Staff Report

To: Salt Lake City Historic Landmark Commission
From: Kelsey Lindquist, Planning Manager, (385) 226-7227
Date: October 1, 2021
Re: PLNHLC2020-00376

Minor Alteration

PROPERTY ADDRESS: 1106 E. South Temple
PARCEL ID: 16-05-202-001-0000
MASTER PLAN: Avenues Master Plan, 1987
ZONING DISTRICT: R-2 (Single and Two-Family Residential)

Post Enforcement Photo of South Elevation

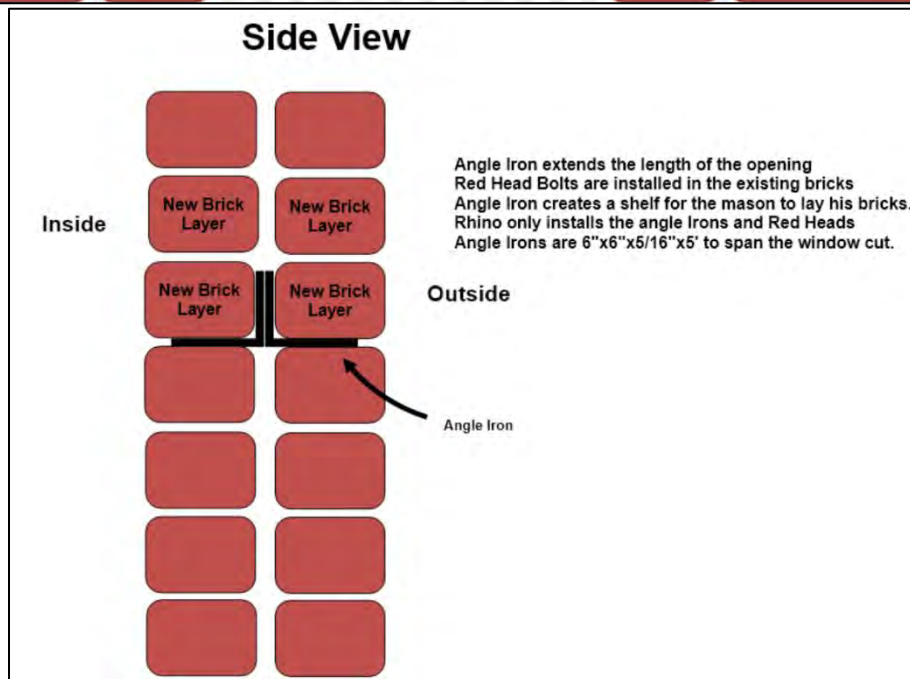
The egress window approved on the primary elevation was not cut according to the approved plans and the certificate of appropriateness. The contractor cut the egress opening below the main level bay window. This egress opening was not approved to be above grade and visible. In addition, an unapproved egress opening was cut above grade on the rear elevation of the subject property. Please note, the two egress openings on the western elevation were cut according to the approved plans. The location of this egress opening on the east elevation is correct; however, the issue remains, similarly to the north and south elevation, is the methodology in which the opening was cut and the extensive damage caused to the masonry. The following photos illustrate the egress openings that have been cut into the foundation. Please note, all egress windows are proposed to be Sierra Pacific wood casement windows.

Due to the state of the masonry and the enlarged openings on the northern, east and south elevations, staff indicated that there are significant structural concerns because of the new openings. Staff requested that the applicant hire and consult with a mason well-verse in historic masonry repairs and restoration. The engineer and architect provided a plan for the foundation reconstruction for the egress opening on the north, south and east, which can be referenced below and in Attachment B. To correct the opening within the foundation, the architect and mason are proposing to install an angle iron to stabilize the stone and then match the existing sandstone with new and salvaged pieces, a match is illustrated in the photo below. Staff is recommending approval for this reconstruction solution.

Archived Photo from 1906

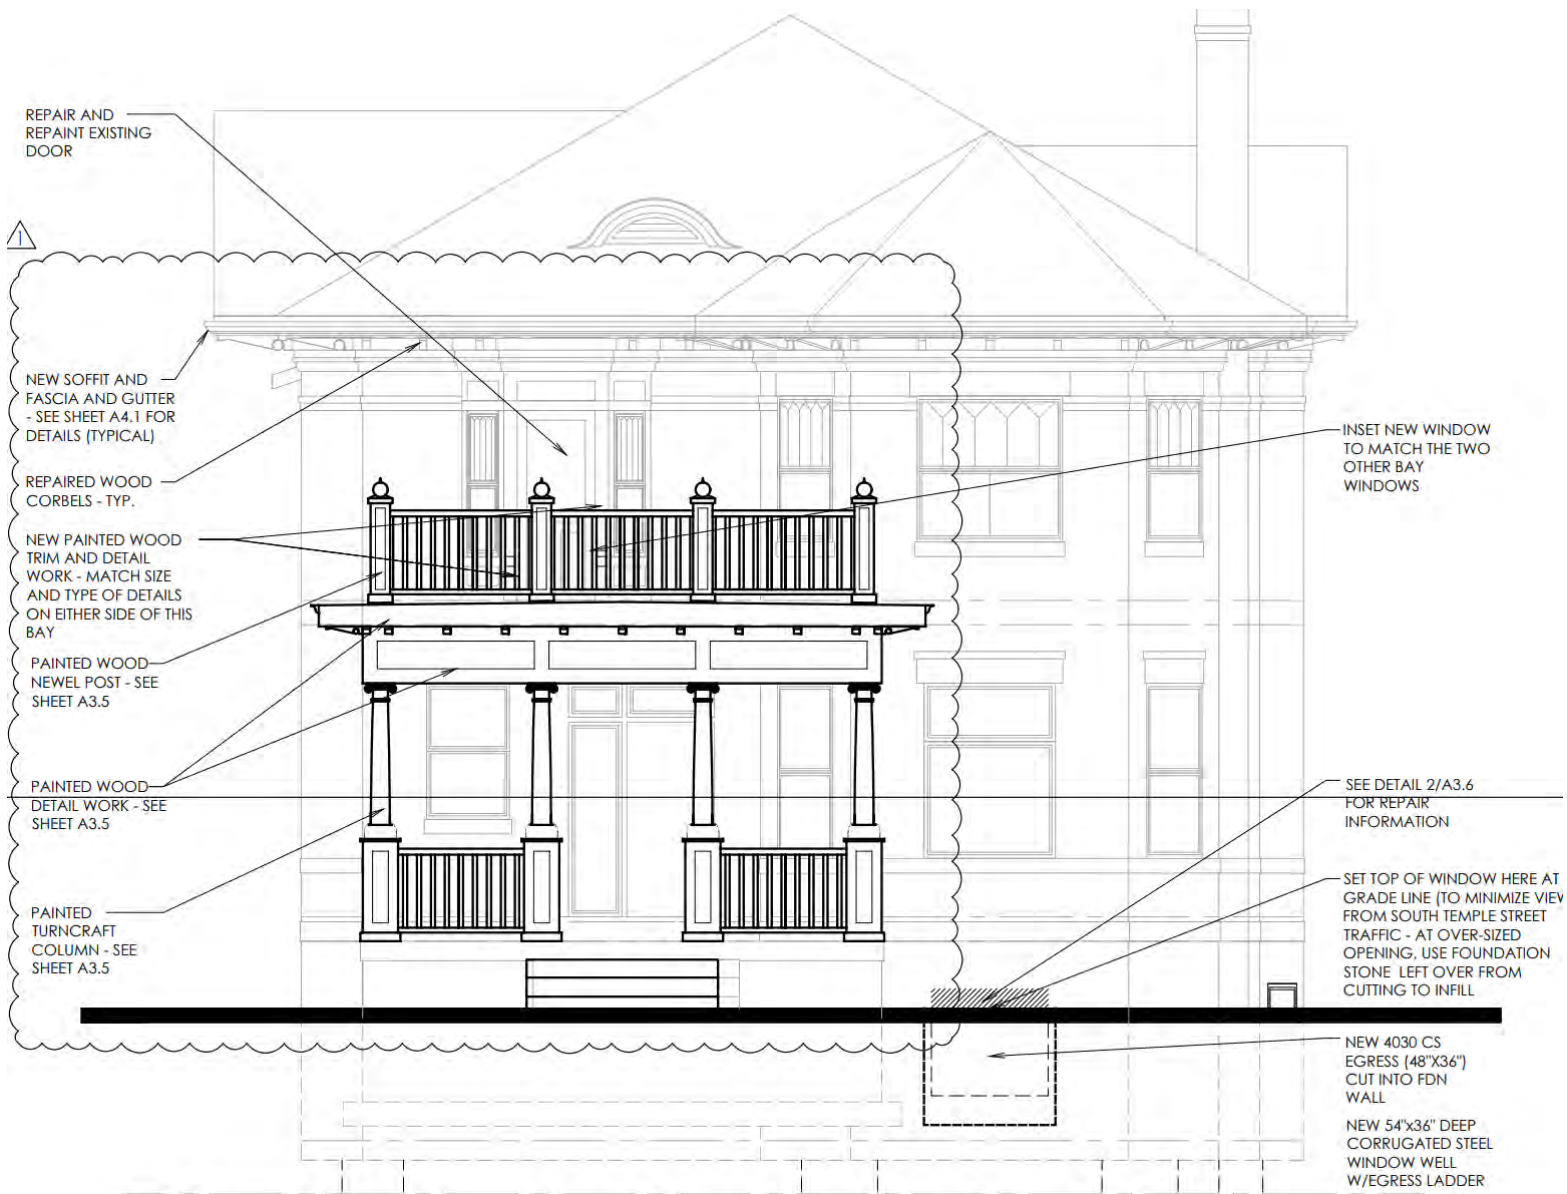
Based on the two archived photographs, provided below, of the subject property from 1906, the architect developed a reconstruction proposal similar to what had previously existed.

Installation of Incorrect Windows on the Southern

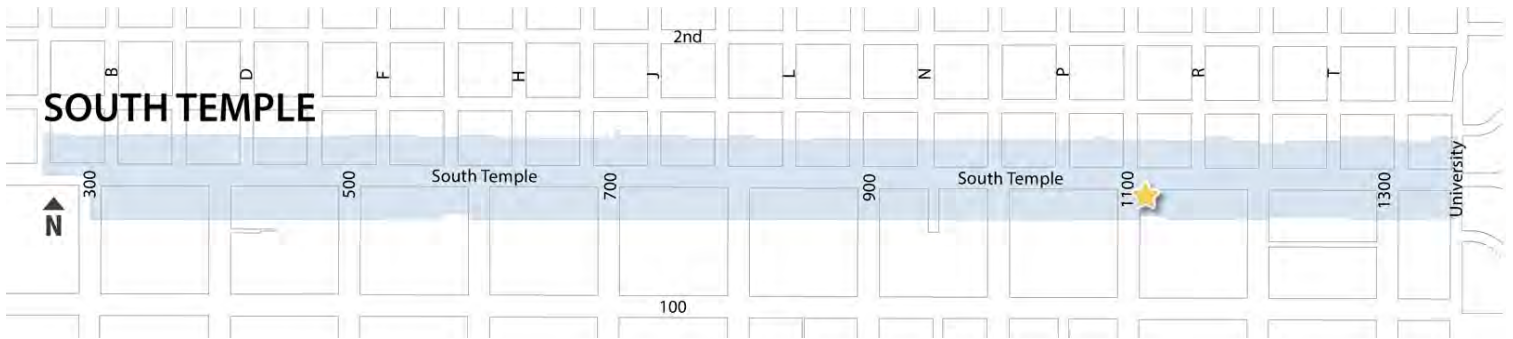
Vinyl horizontal sliding windows were installed in the rear addition, prior to the initial enforcement case in 2020. Staff worked with the applicant and architect to approve appropriate windows for the addition. Eventually, the applicant proposed casement windows on the southern and eastern elevations of the addition. The applicant has yet to correct the vinyl horizontal sliding windows on the southern elevation and the eastern elevation.

1 BASEMENT WINDOW REPAIR DETAIL
A3.6 SCALE (24x36): 1/2"=1'-0"

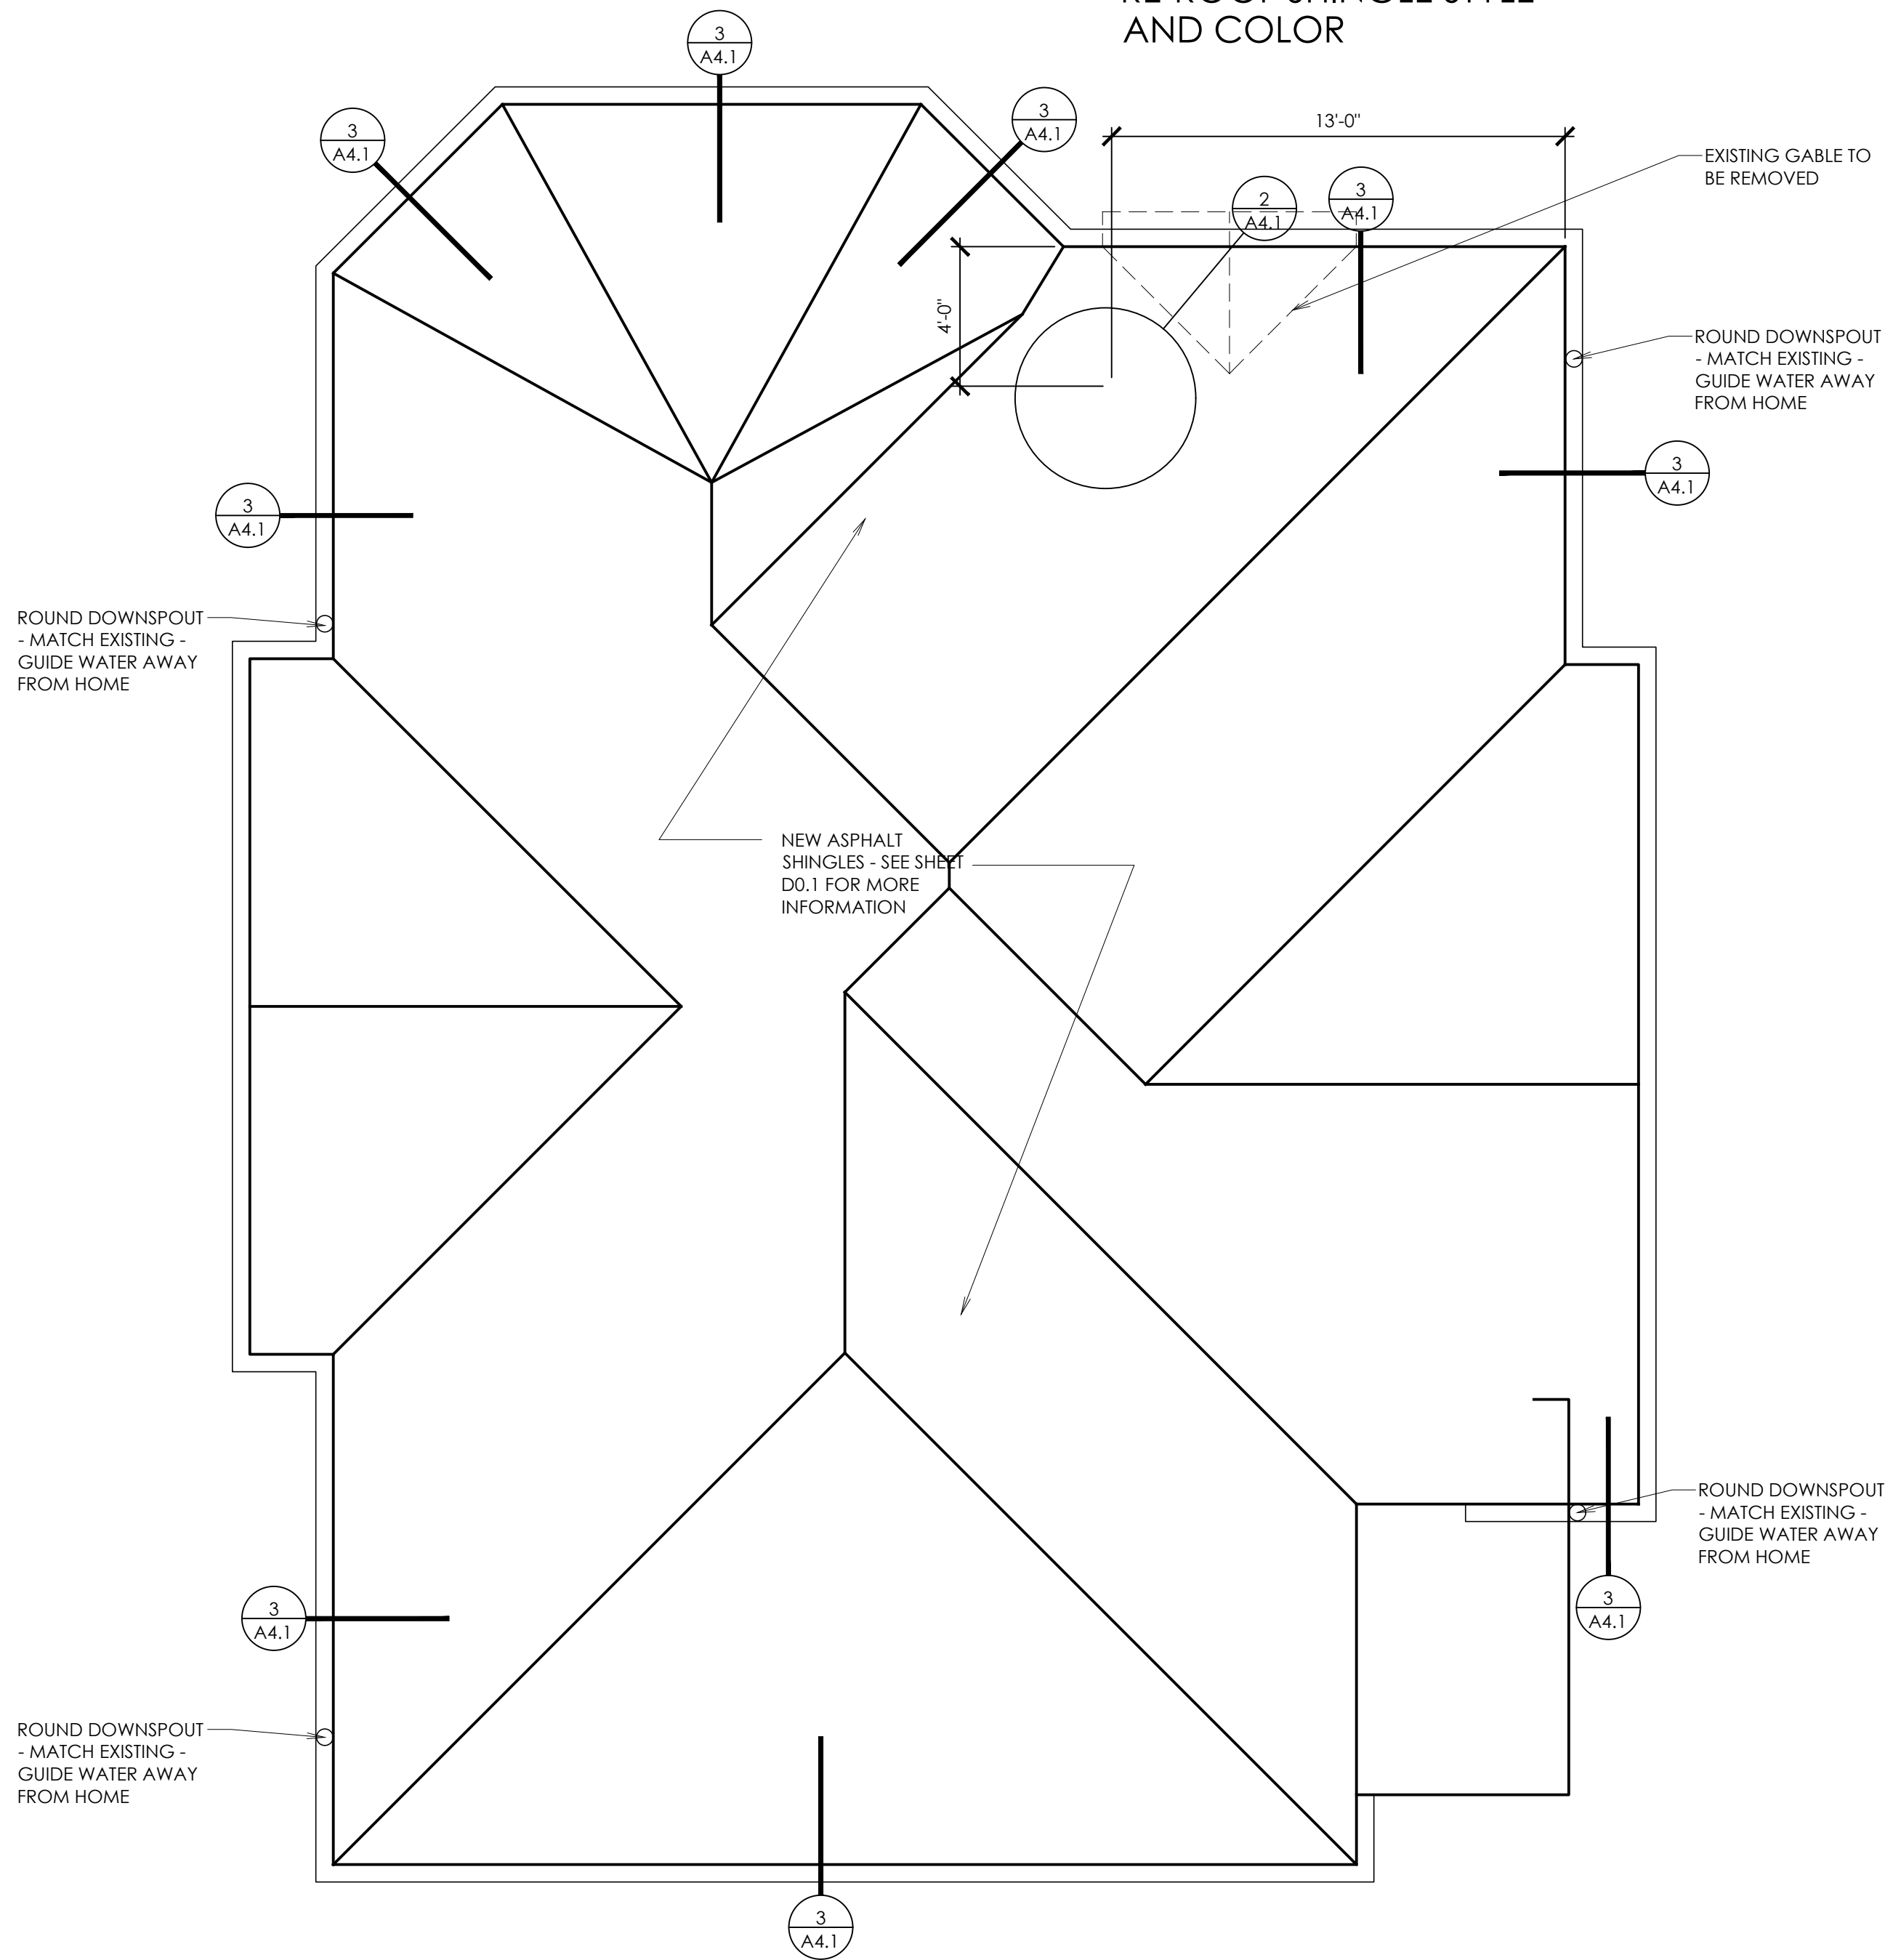
The applicant believes that the removed sandstone can be reused in the incorrect egress opening. Unfortunately, many of the stones were cut and will likely be unusable. The applicant provided additional information on where new sandstone will be sourced and how the applicant will ensure a correct and compatible match. Any original stone and new stone will need to be placed with a historic and compatible mortar, so that any future foundation issues can be avoided.

Due to the extent of the work conducted, staff is concerned that the foundation cuts will be challenging to correct. Based on requests from staff, the applicant provided a proposal to reconstruct the foundation, and the information on the mason hired to perform the work. While the applicant is confident in the methodology proposed, staff remains concerned that the alteration to the character defining feature of the foundation will remain difficult and challenging to repair.

I am providing more detailed information on the basement window modifications that need to be addressed and fixed. The detail that I have provided will be applied to the following basement windows that are in these photos in the order as mentioned. The egress window North facing north west corner. East facing egress window northeast corner. South facing subgrade window. We need to fill in the areas that have been cut with the natural Stone to bring it to its original look. To accomplish this we first need to use the original Stone that was installed. The stone is called Cherokee and it comes from the Heber Valley. American Stone in Salt Lake City will be the supplier. The matches as you can see in the photos match perfectly to the original stone. The stone cannot be simply put into place with mortar and be expected to hold satisfactory. The detail that has been provided is from rhino foundations who are in engineering foundation repair company. They have come up with a design that will be built out of flat steel and welded into place. The configuration will have a backing on the inside of the home along with pieces on the bottom that will hold the stone into place. When the stone is put into place and mortared the steel will also act as rebar reinforcing the stones integrity. Once the stone is into place from the outside you will not see any of the steel apparatus. The stones will also be cut accordingly to meet the length height and where the joints should be into place to match and be consistent with the existing stone. Once we have completed this process the new stoned that has been installed will be more secure and stronger than the existing stone. The Mason that is installing this has over 20 years experience in the industry on natural Stone and he is confident once completed it will look as if the stone was never cut or in other words it won't look like a patch job.
